ADDENDUM NO. 4 TO BID DOCUMENTS

Date: June 18, 2025
Project: Utley Creek WRF - Lab & Operators Building
Owner: Town of Holly Springs
Engineer: Hazen and Sawyer

Addendum No. 4

ATTACHMENT NO.
1

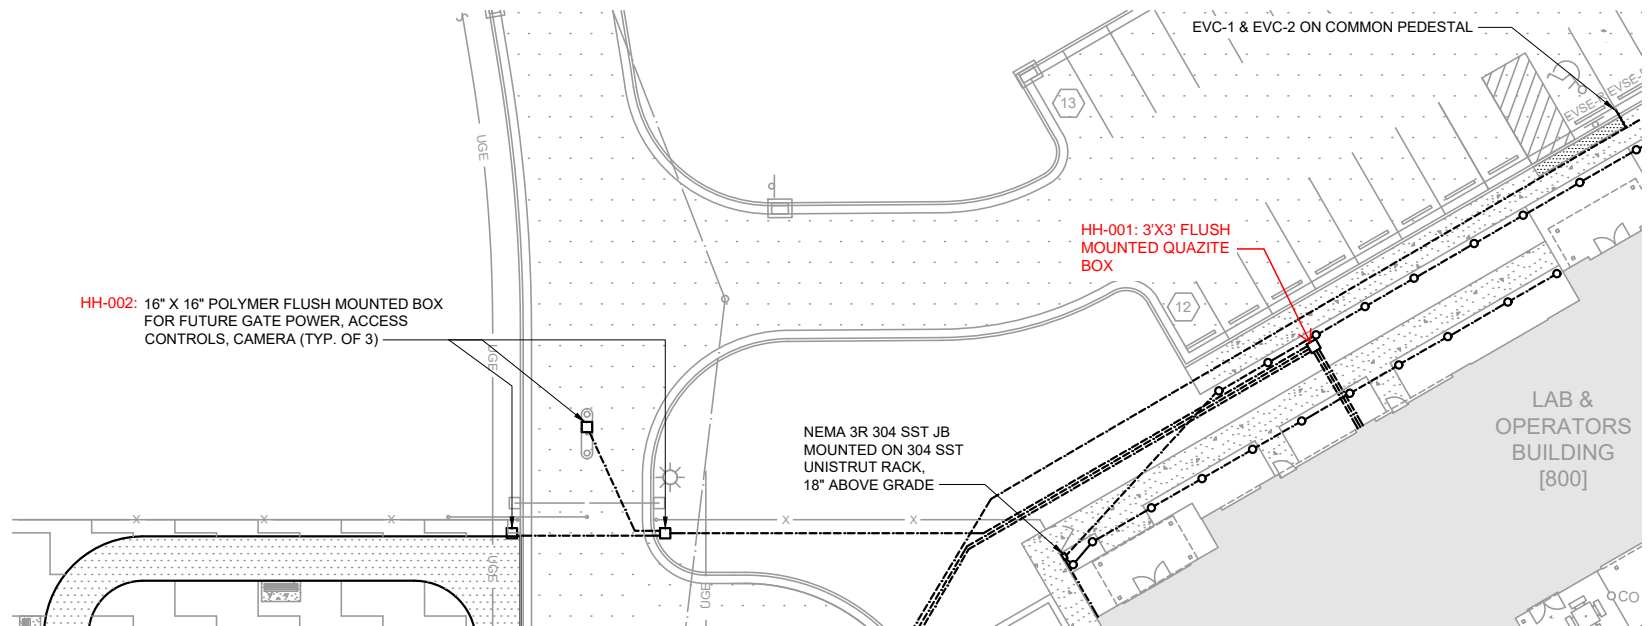
A005 Replace Door Schedule with table provided in **Attachment #1**.

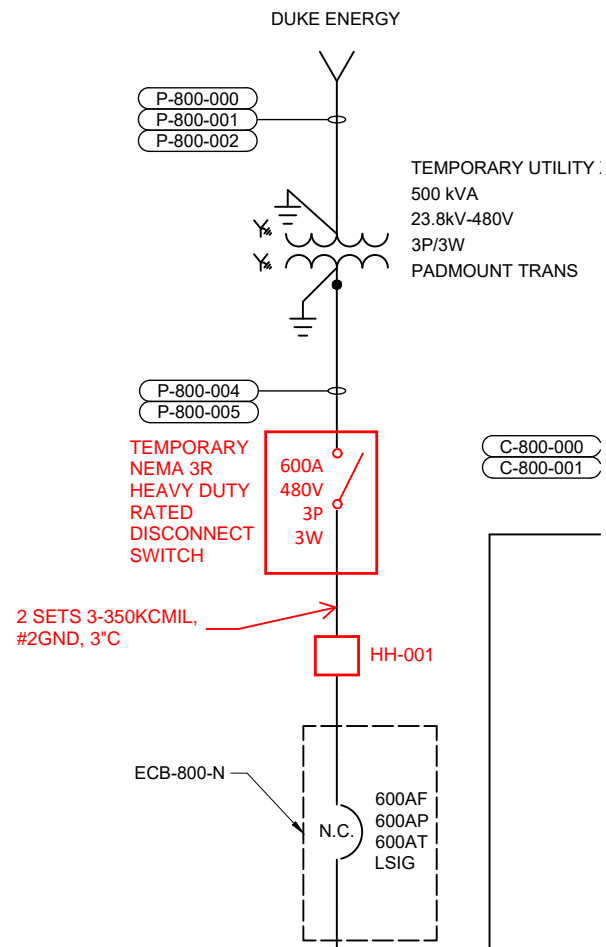
E003 Reference **Attachment #2** for handhole tags on sheet E003.
